# UNITED STATES PATENT AND TRADEMARK OFFICE

APPLICATION NO.	FILING DATE	FIRST NAMED INVENTOR	ATTORNEY DOCKET NO.	CONFIRMATION NO.
10/809,055	03/25/2004	Scott Lauffer	DC-06923	7005
33438	7590	02/06/2006	EXAMINER	
HAMILTON & TERRILE, LLP			PAPE, ZACHARY	
P.O. BOX 203518			ART UNIT	
AUSTIN, TX 78720			PAPER NUMBER	
			2835

<b>Office Action Summary</b>	Application No.	Applicant(s)	
	10/809,055	LAUFFER ET AL.	
	Examiner	Art Unit	
	Zachary M. Pape	2835

**Fig 1**

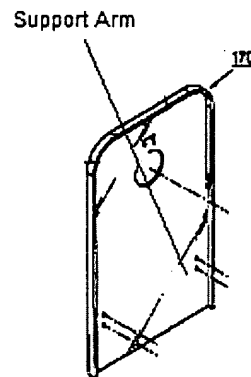
With respect to claim 9, Jung et al. teaches an information handling system peripheral cable management system comprising: a support base (130) operable to rest on a surface; a peripheral base (180) operable to couple to a peripheral, a support member (10) coupled between the support base and the peripheral base, the support member disposing the peripheral base vertically over the support base (As shown in Fig 3), the peripheral base vertically positioned to couple to a peripheral (As illustrated in Fig 3); and a cable clip (170) having a support arm (73/77) and a guide (As illustrated in present office action Fig 2 below), the support arm having a first end connecting to the support member (Via 70) and a second end (As illustrated in present office action Fig 2)

extending outward from the support member, the guide having an opening (150) in a plane, the plane aligned substantially parallel with the support member and substantially perpendicular to the support arm to accept cables from the peripheral and maintain the cables in an accessible position.

With respect to claim 1, Jung et al. teaches a flat panel display (120) operable to present visual information generated by processing components; a stand (130) operable to mount the flat panel display in a vertically raised position and to support movement of the flat panel display in variable positions (As illustrated in Figs 7, 8a, and 8b), one or more cables (122) interfacing the housing to the flat panel display (As illustrated in Fig 2); and a cable clip (170) extending outward from the stand, the cable clip having a guide (150) forming an opening in a plane and having a support arm connecting the guide to the stand (As illustrated in present office action Fig 1 below), the opening aligned substantially perpendicular to the support arm (As illustrated in Fig 2) to constrain the cables within the cable clip during movement of the flat panel display between the variable positions (Wherein the variable positions of the display are shown in Figs 2, 7, 8a, and 8b). Jung et al. fails to teach the display attached to a housing with plural processing components. Honda teaches a display (122) with a housing (5) with a plurality of processing components (81, 86) disposed within the housing. It would have been obvious to one of ordinary skill in the art at the time the invention was made to combine the processing components and housing of Honda with the display of Jung et al. to provide the display of Jung et al. with data processing capability.
